Recall Campaign 10V-518: E70 N52K Replace Electric Fuel Delivery Unit

E70 (X5) with N52K engine produced from November 1st, 2007 up to August 31th, 2008

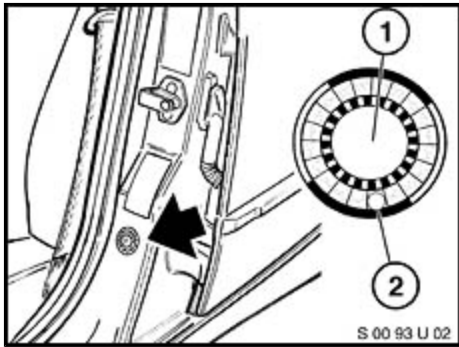
Due to a manufacturing process error, the electric fuel pump was not produced to specifications. The premature wear of the pump's commutator/brushes may cause a fuel pump failure. The engine may stall during driving, and restarting would not be possible.

Replace the Fuel Delivery Unit (P/N 16 11 7 295 459). Follow Repair Instruction REP16 14 010 (Replace electric fuel pump).
